Analysis of EU policy proposals for DG ENER Lot 12 Commercial Refrigeration

Including comparison with policy thresholds and product data from other regions

21 August 2014

Figure 7. EU proposals alongside requirements from the UK and Australia (no relevant requirements exist for USA[26]) - all lines refer to integral, frozen, horizontal cabinets of closed type and are normalized to an L1 reference temperature.

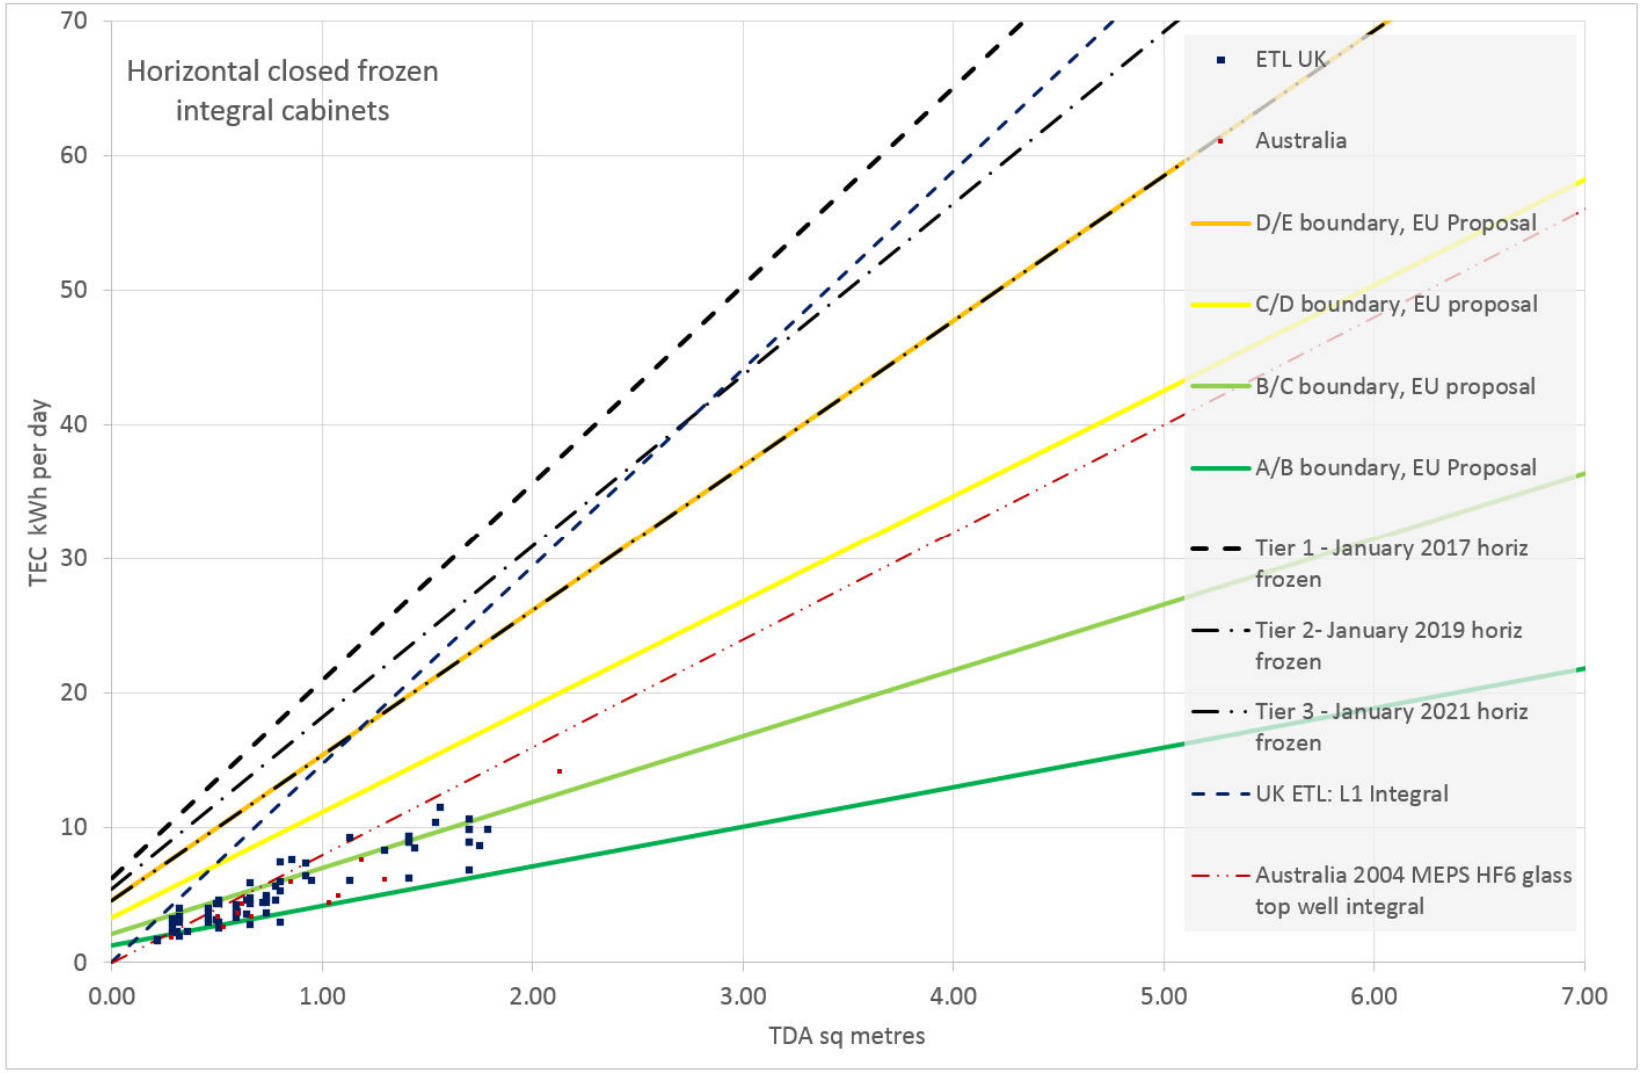
5. Closed cabinets from the UK are seen to be clustered in energy class B, with a few in class A (Figure 7). This leaves little scope for differentiating future best performing cabinets as most are likely to be class A. At least the higher label classes (A, B, C) should be made more stringent to allow continued differentiation once the market is moved substantially over to closed cabinets. This bunching at class B currently affects only integral cabinets (being smaller in TDA) but may also be relevant to remote cabinets in due course (remote closed cabinets from Eurovent Certification are mostly label D at present).

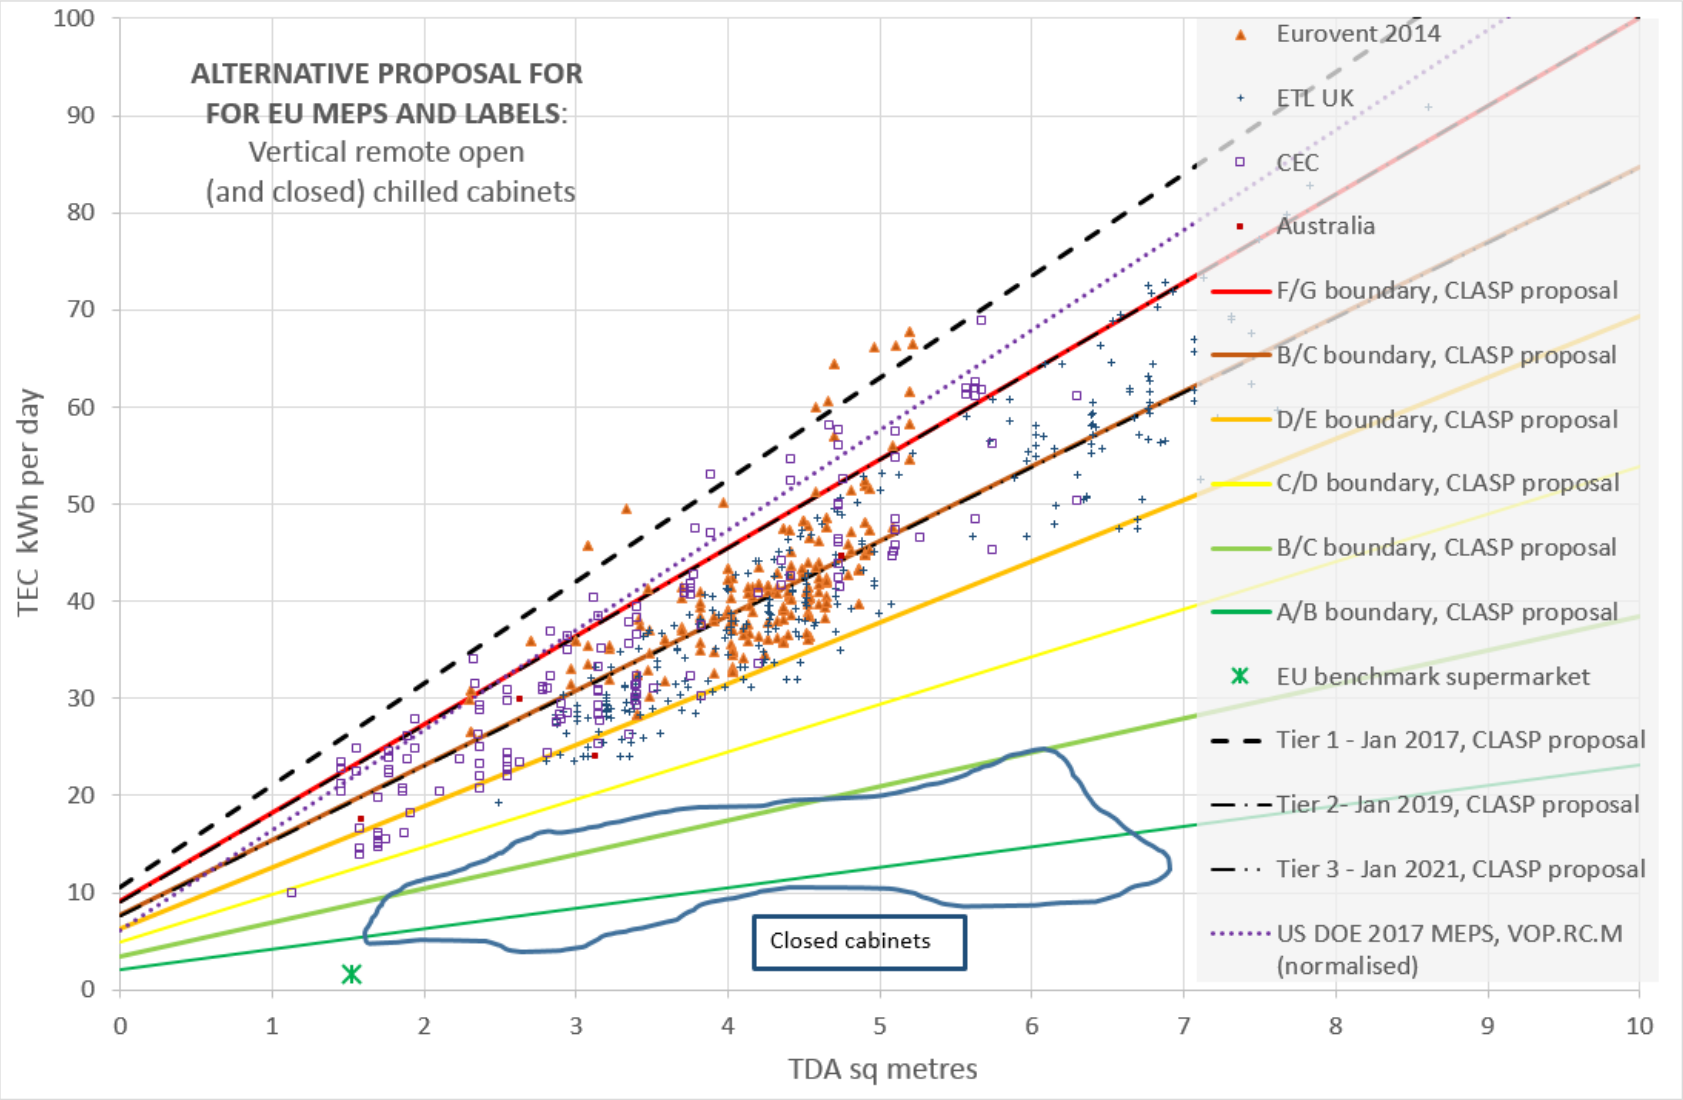
The primary driver for proposing alternative MEPS and labels for RDCs is to ensure that the regulations strongly encourage use of doors but still allow for continued availability of highly efficient open cabinets. Figure 3 shows that the current proposals for MEPS even at 2021 will allow continued availability of the majority of open cabinets in these data sets. Whilst many poor efficiency cabinets (not present in these data sets) would undoubtedly be removed by these MEPS, sufficient supply would remain to maintain similar presence in shops as today. Also, the uneven distribution of label classes means there is less scope to differentiate products in the most populated zone of performance.

Figure 8 shows proposed alternative MEPS and labels (and should be compared with Figure 3). For this alternative proposal, the reference line has coefficient M (slope) and N (intercept) of 7.0 and the new energy label class boundaries are shown in Table 1. This proposal makes no change to the MEPS in terms of EEI (although the reference line change alters their level of performance).

Figure 9. Proposed EU MEPS and labels for beverage cabinets.

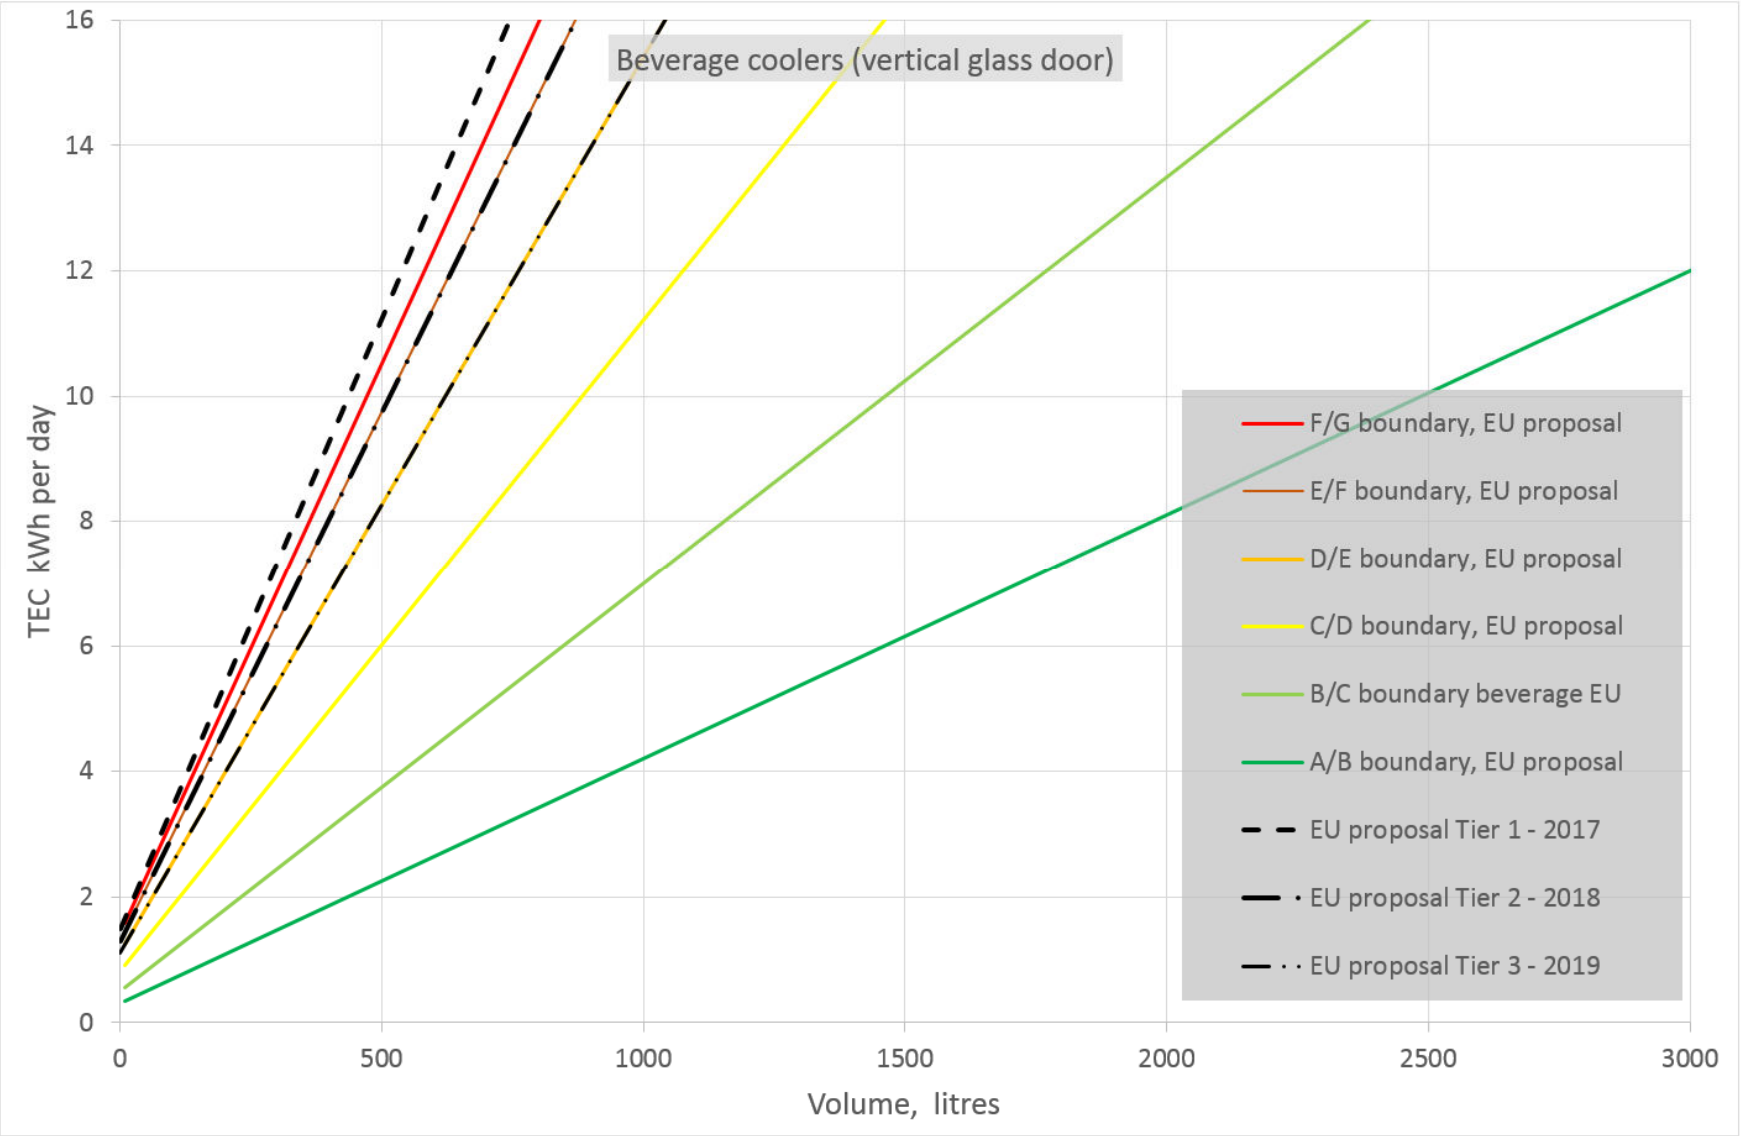
1. Figure 9 shows that the proposed EU MEPS for 2017 do not align with any label class boundary and are set lower than G class – hence after 2017, G label cabinets can still remain on the market.

Figure 10. Comparison of proposed EU MEPS and labels for beverage cabinets with criteria for USA (DOE MEPS for beverage coolers with pull-down capability in 2017; DOE MEPS for glass door vertical cabinets 2010 (from US code section 6313) and 2017 (from 10 CFR Part 431).

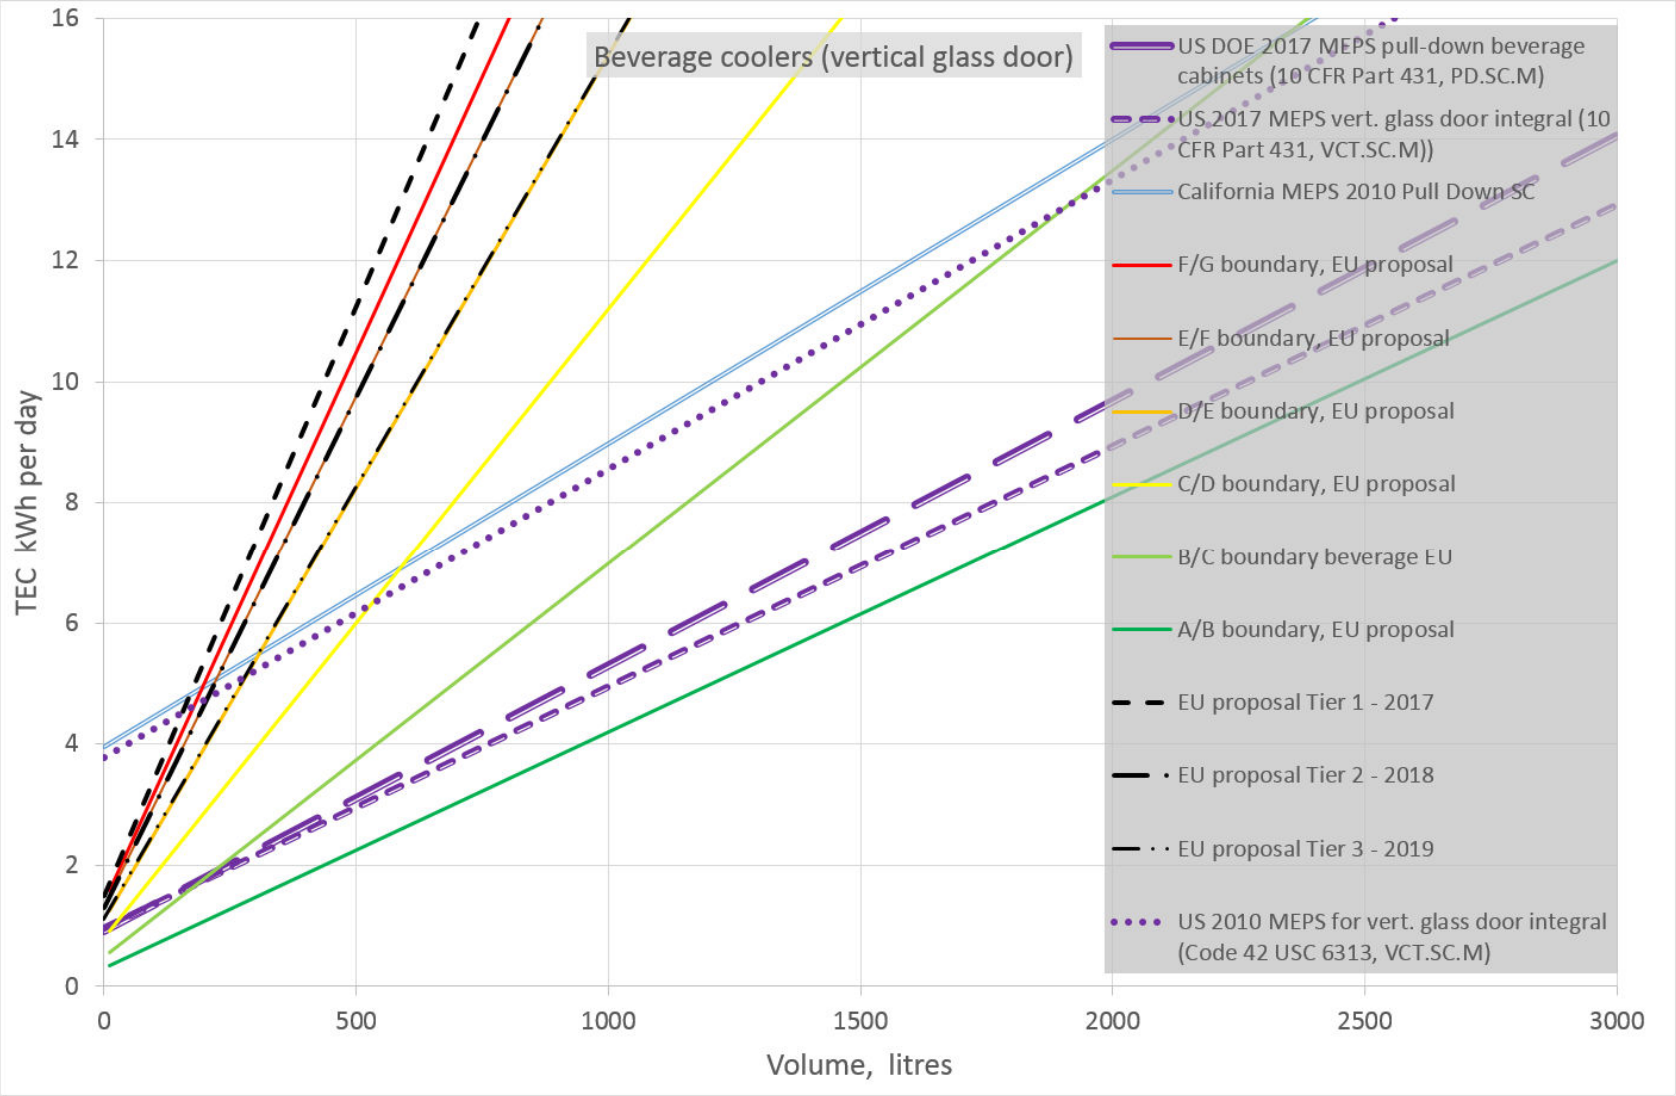
5. In Figure 10, for a standard full height single glass door cabinet (around 500 litres), the 2017 EU requirements (11 kWh/day) will allow for nearly twice the energy consumption of the US and Californian MEPS that took effect in 2010.[27] Even the 2021 EU requirements for this popular size allows 25% higher consumption than the US MEPS of 2010 – implying that the EU market would be allowing efficiency levels over *15 years behind those of the US*.

Figure 12. An alternative scheme of MEPS and label thresholds for the EU, compared with criteria for USA (DOE MEPS for glass door vertical cabinets 2010, beverage cabinet MEPS for 2017 and US ENERGY STAR V2.1 criteria (2009) with ENERGY STAR V3 criteria (October 2014).

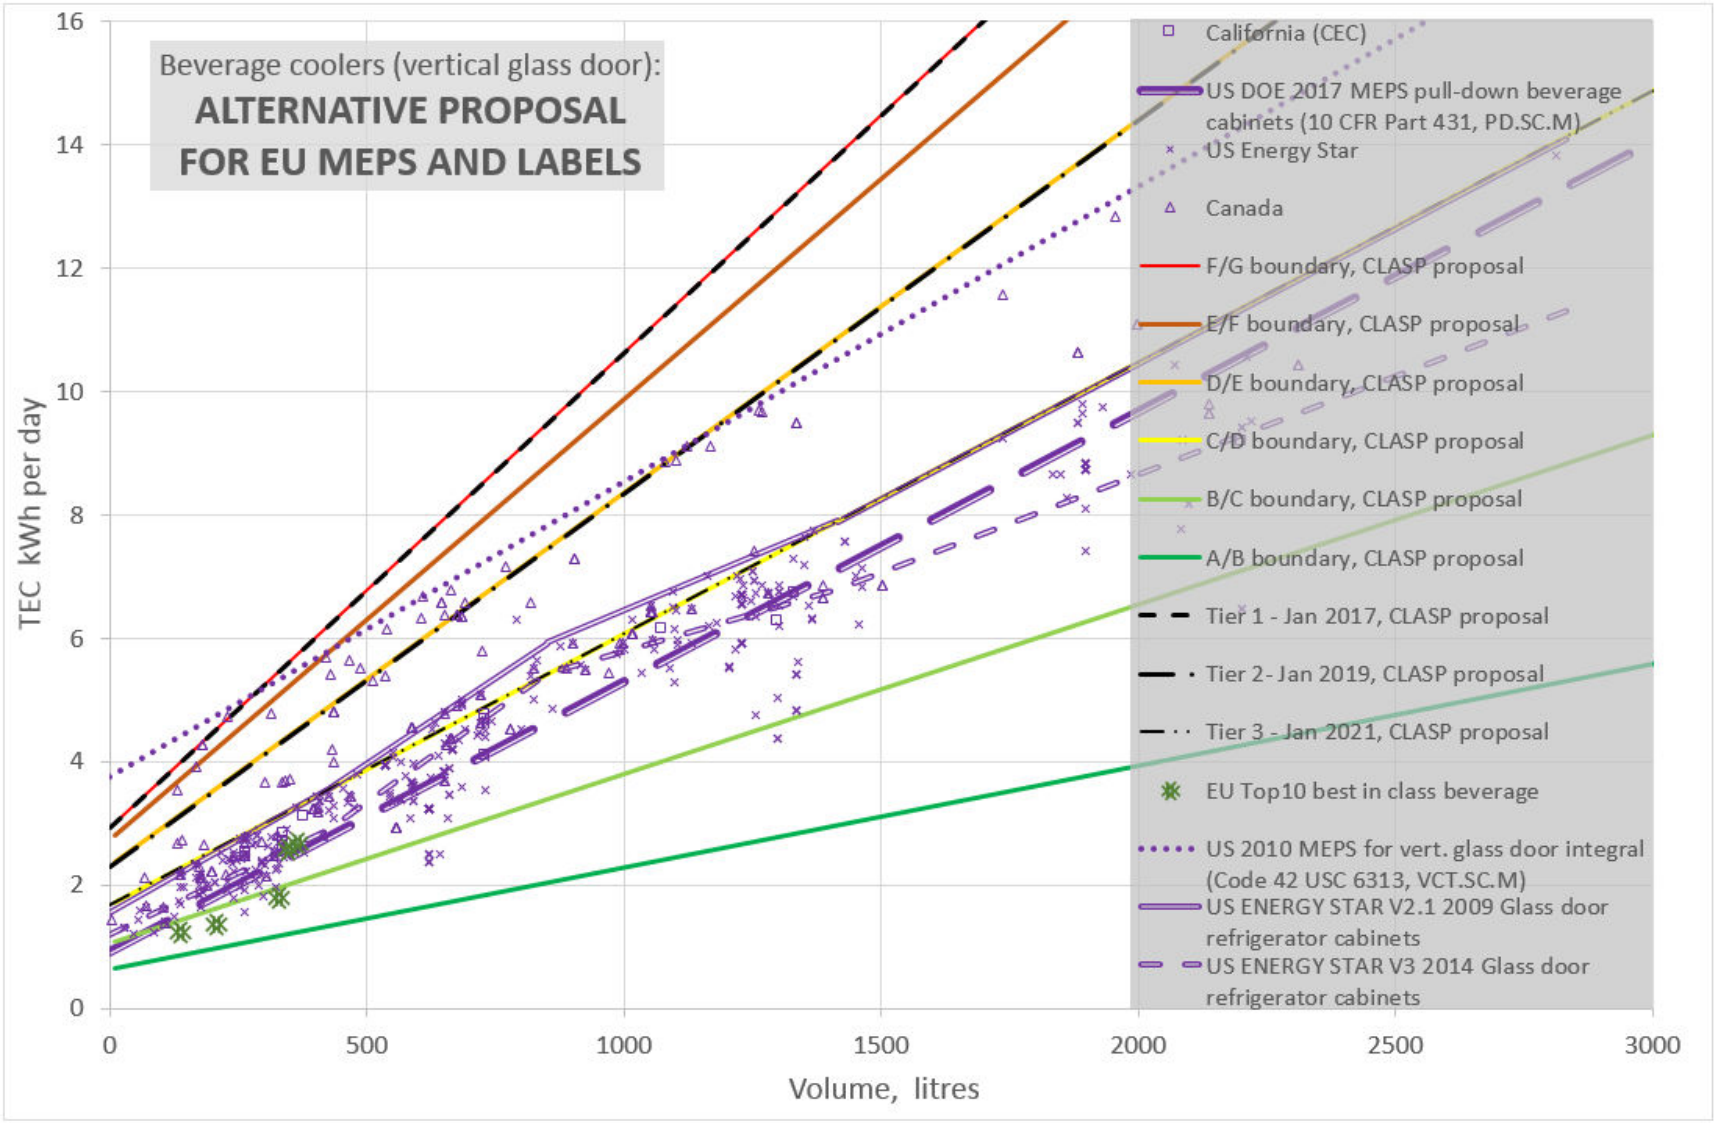
This proposed alternative MEPS and labelling thresholds are shown in Figure 12, from which it can be seen that:

1. The Tier 1 MEPS are only slightly more stringent than the 2019 US MEPS for the smallest cabinets (previously, they were far more stringent than the US under 300 litres);
2. The Tiers and labels will have an impact on cabinets across the whole size range;
3. With Tier 2 in 2019, the EU market would be better than the US market of ten years earlier (2010);
4. EU Tier 3 of 2021 is almost identical to the ENERGY STAR requirement of 2009 (12 years earlier), but still allows 30% higher consumption than the US MEPS of 2017 (4 years earlier);
5. There are a few best performing cabinets on the EU market today that achieve label class B, with scope to encourage even further improvements to class A; and
6. The US minimum requirement for beverage coolers falls within label class C.
